**AVONDALE'S ACT 537 PLAN (BOOK 1)**

*ACT 537 PLAN  
BOROUGH OF AVONDALE  
CHESTER COUNTY, PENNSYLVANIA*

*SEWAGE FACILITIES PLAN*

*May 1999*

APPENDIX 3  
WATER SYSTEM MAP

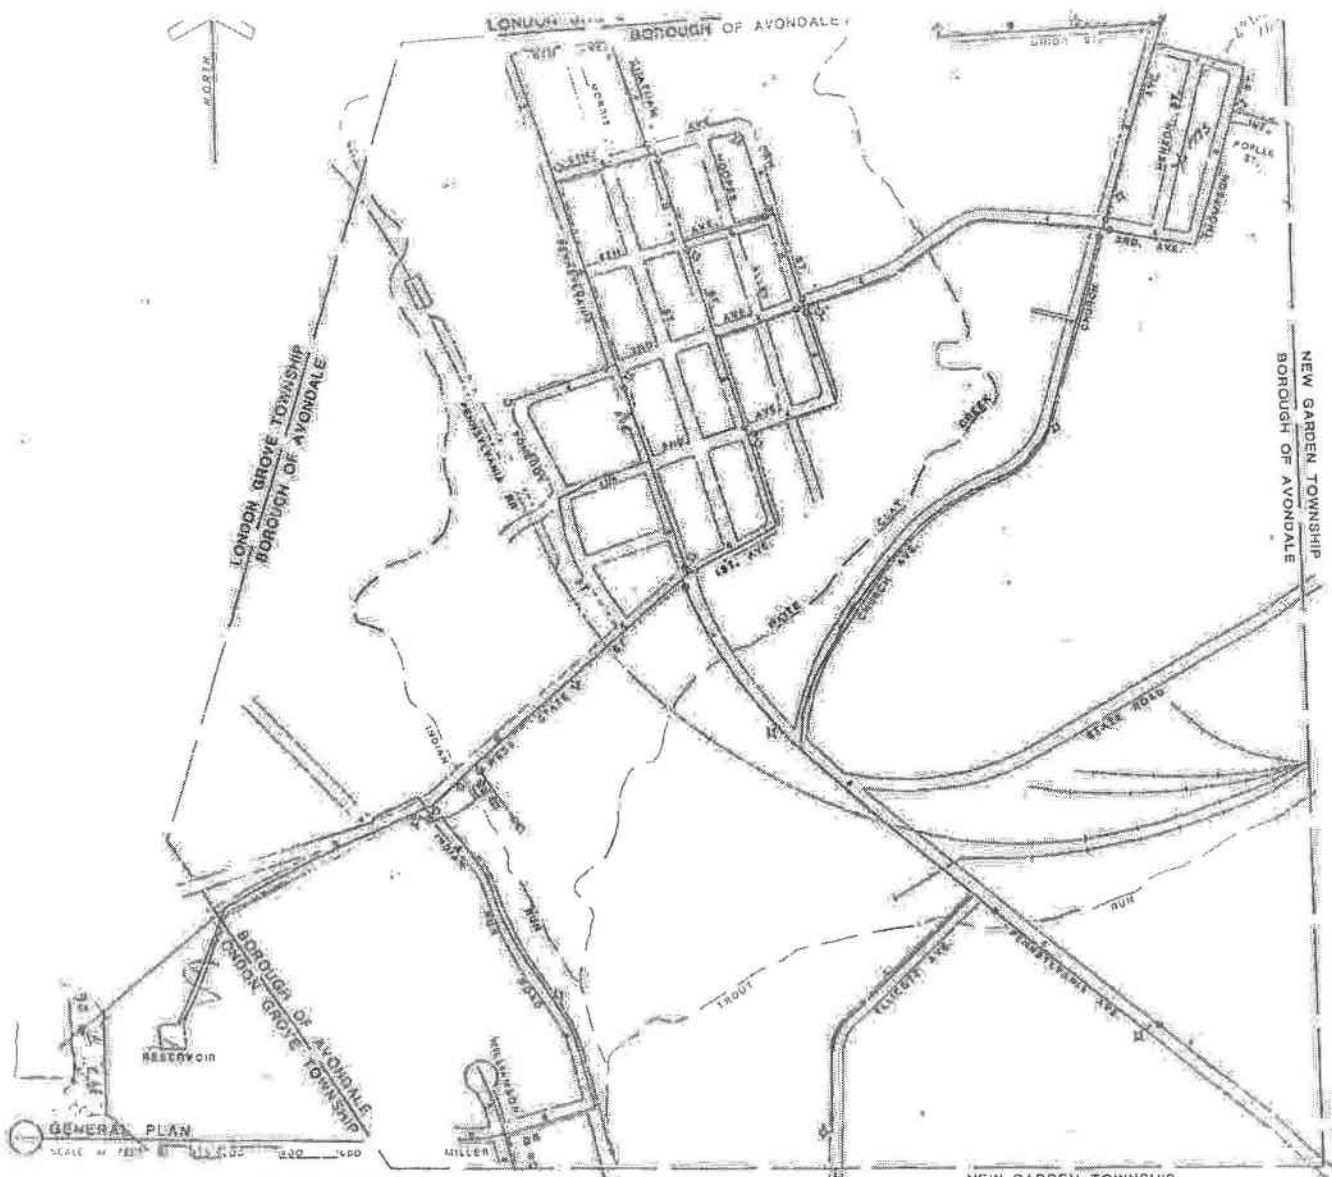
7. Page 87 - Item 1, first sentence 4th word - "revised" should be changed to "completed". (see page 92)
8. Appendix 3 - "State Road" should be changed to "Baltimore Pike". Also add "Cook Court" to the map.
9. Appendix 5 - Change "State Rd. (Rte. 1)" to "Baltimore Pike". Also "Avon Mohr" should be added to the map.
